ADDENDUM #1

MEANG Building 541 Renovate for Boom Operator Simulation System - BGS Project # 3430

Bangor ANGB, Bangor, ME 04401

7 August 2023

ATTACHMENT A

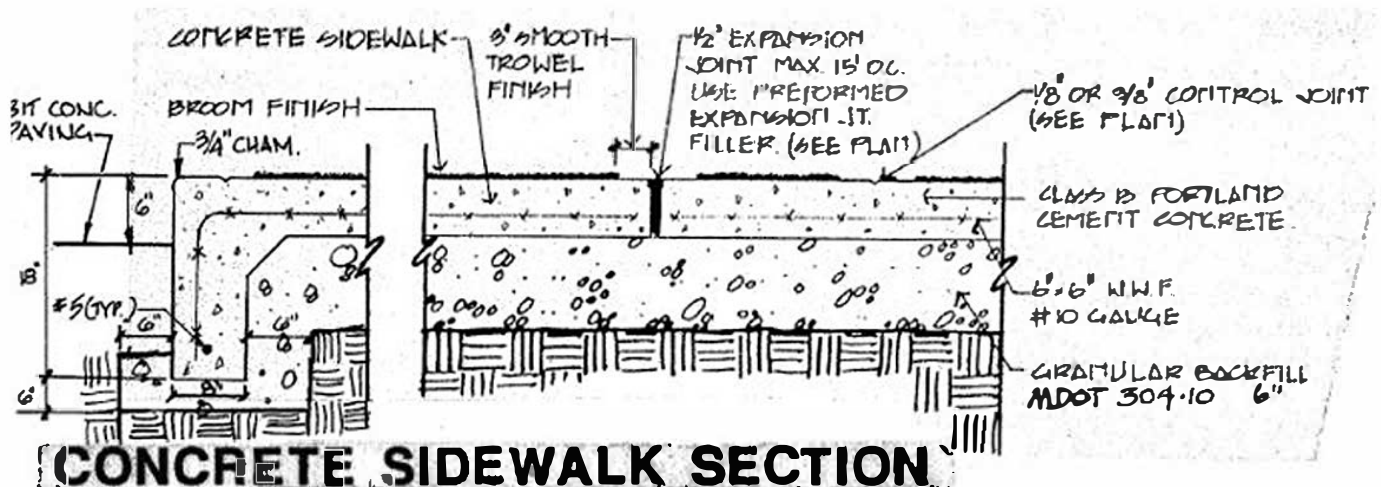
3. **For the New Underground Utility Conduit Trench please provide specifications and detail on concrete walkway patch against Building 541.**
 - a. Please see Attachment A. (CR, 101CES)

1. THE EXISTING CONCRETE HAS A DEPTH OF 6" THAT WILL REQUIRE REMOVAL .
2. FOR APPROPRIATE RESTORATION SAW CUT CONCRETE SECTION WILL NEED TO BE JACKED, DISPOSED OF AND RE POURED.
3. IF CONCRETE IS CUT ON EXPANSION JOINT, REPLACE JOINT, SEE CONCRETE DETAIL BELOW
4. MATCH 6"X6" EXISTING WIRE MESH OF EXISTING CONCRETE, SEE DETAIL BELOW

Figure 2: RSS Power Panel and ECU Locations

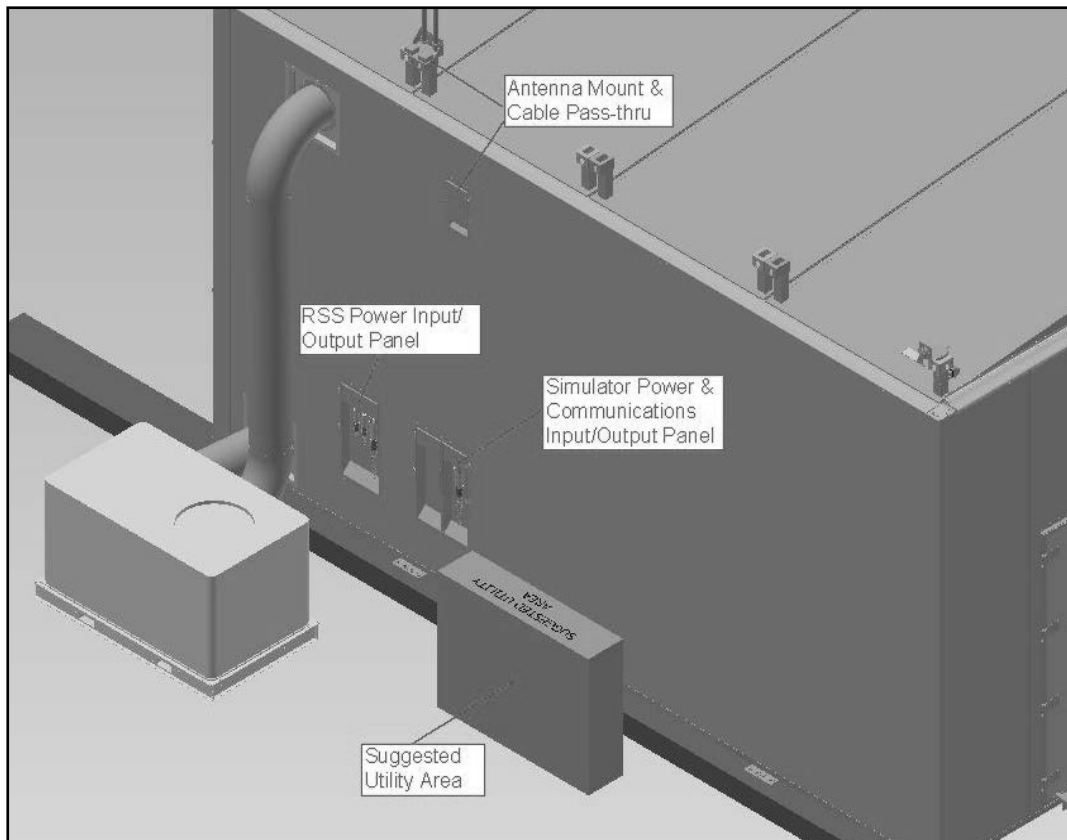
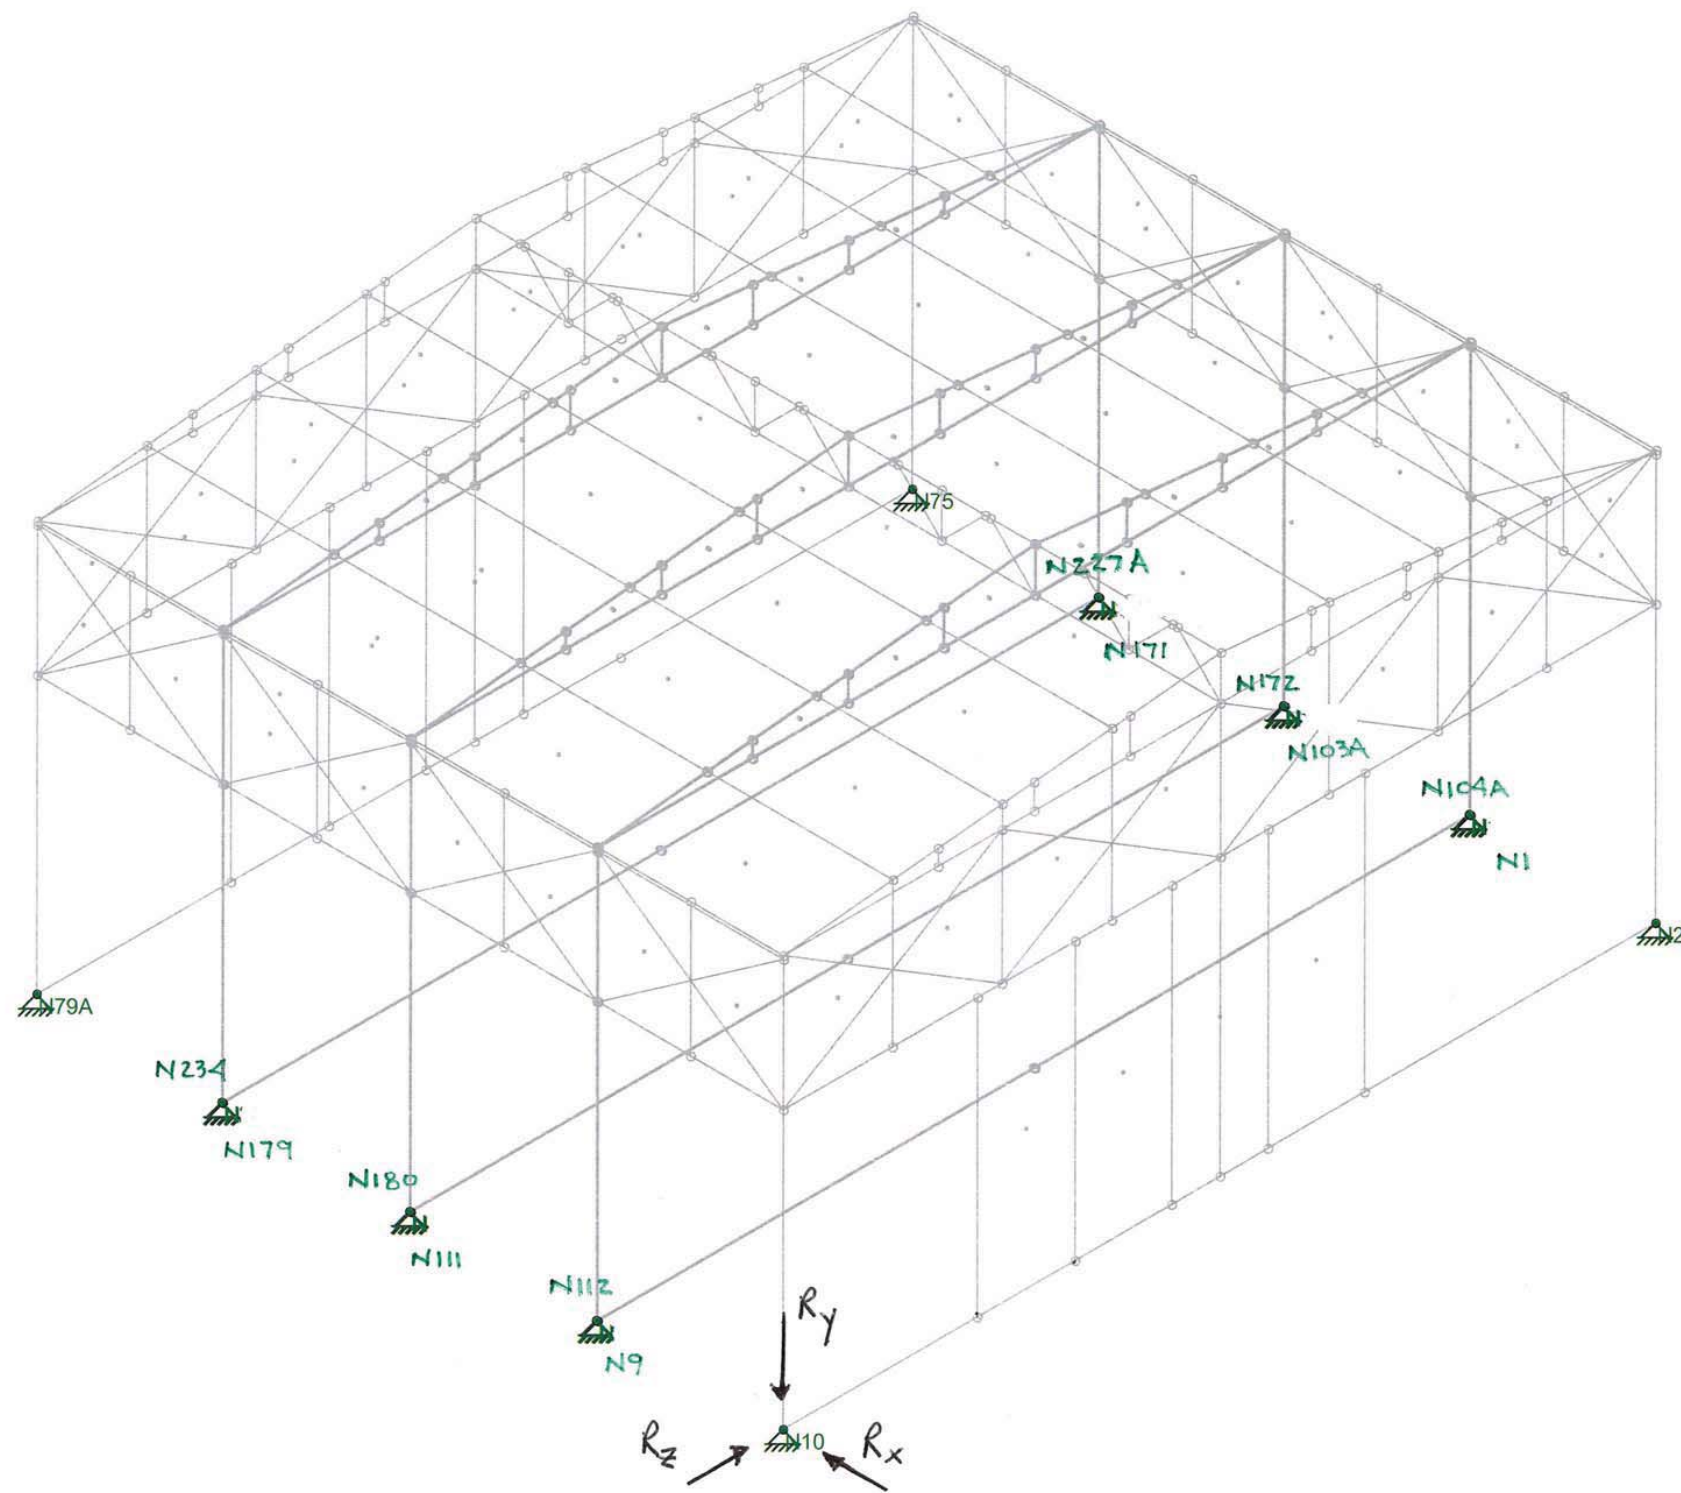
5. **During our Pre-Bid site walk, it was discussed that electrical and possibly telecommunications scope will be added to the project. Please confirm these requirements and provide electrical & tel-com drawings and specifications. a. Conductor Requirements b. RSS Utility Pedestal detail and specifications c. Interior Building 541 electrical requirements d. Etc.**

Electrical conductor requirements are found in RSS Utility Preparation, sec 7.1.2/3. “Provide disconnect and cable sized to power the RSS with 120/208V, 200 Amp panel... Ensure the PVC extends up past the slab by 2 feet and has a freestanding weatherproof disconnect... The installed simulator will require the same power setup as the RSS to provide 200 amp service to the “simulator power and communications input/output panel”... When installed, the RSS will have two 200 amp services which includes two 200 amp umbilicals, one for dedicated RSS power and the other for dedicated simulator power.” (TN, 101CES)

Provide disconnect and cable sized to power the RSS with 120/208V, 200 Amp panel. Provide the hardware needed to make all the connections. From the disconnect, run one 4 inch PVC electrical duct. Ensure the PVC extends up past the slab by 2 feet and has a freestanding weatherproof disconnect. Run cable size for 200 Amp panel from disconnect to the slab disconnect. Perform all electrical work in accordance with the latest and greatest version of the National Electric Code (NEC) and in accordance with local and state statues as well as the base approved electrical drawings.
